**IN THE DRAWINGS:**

## REMARKS

Atty Dkt. No.: APPM/008170/DISPLAY/AHRDW/RKK  
U.S. Serial No.: 10/802,363 Conf. No.: 3803  
Filed: MARCH 16, 2004  
Applicant: APPLIED MATERIALS, INC.  
Title: METHOD AND APPARATUS FOR DETERMINING A SUBSTRATE  
EXCHANGE POSITION IN A PROCESSING SYSTEM  
Inventors: DONGCHOON SUH, et al. FIG. 8

FIG. 8

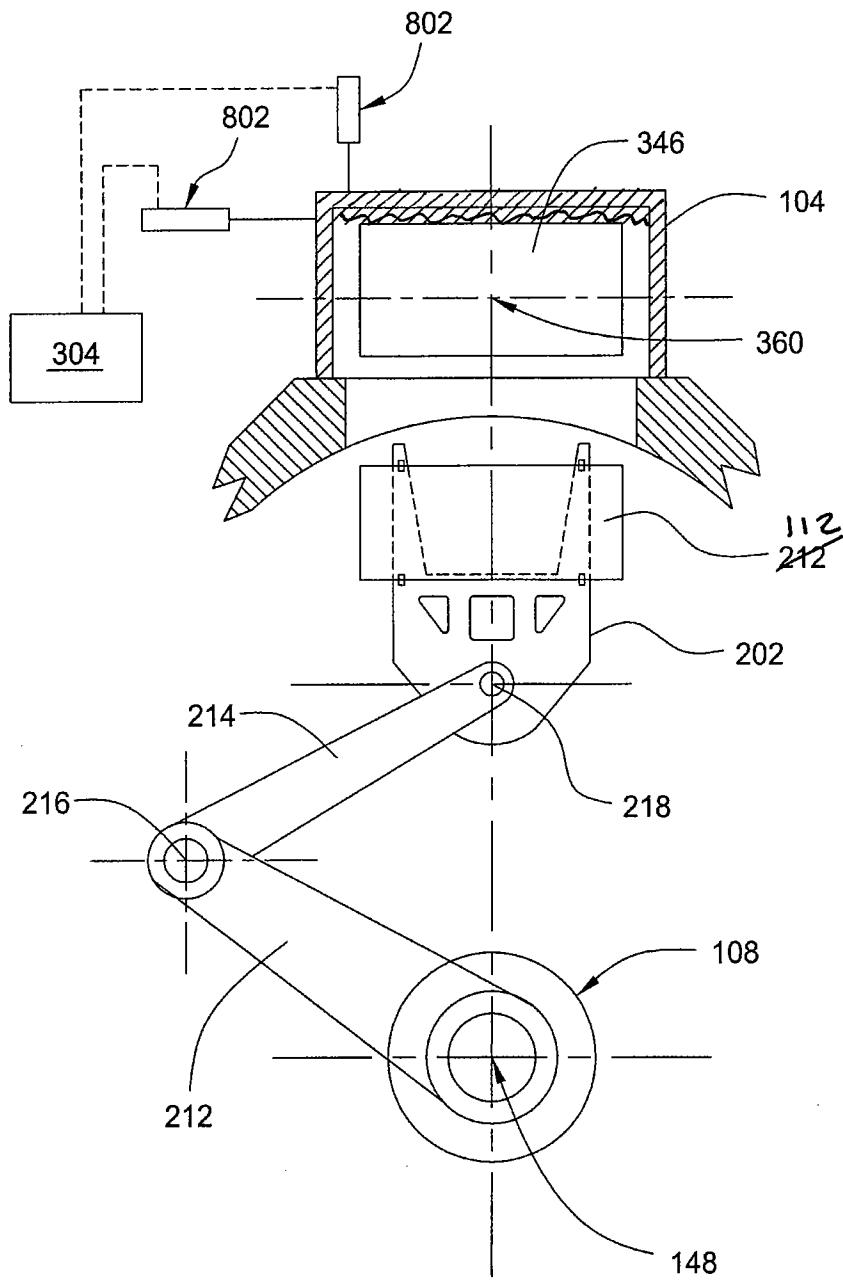
The attached sheet of drawings includes changes to Fig. 8. This sheet replaces the original sheet including Fig. 8. In Fig. 8, 212 has been replaced by 112 to correspond with the specification. Additionally, a minor editorial error regarding cross hatching of item 104 has been corrected.

In amended Figure 8, 212 has been replaced by 112 to correspond with the specification. Additionally, a minor editorial error regarding cross hatching of item 104 has been corrected.
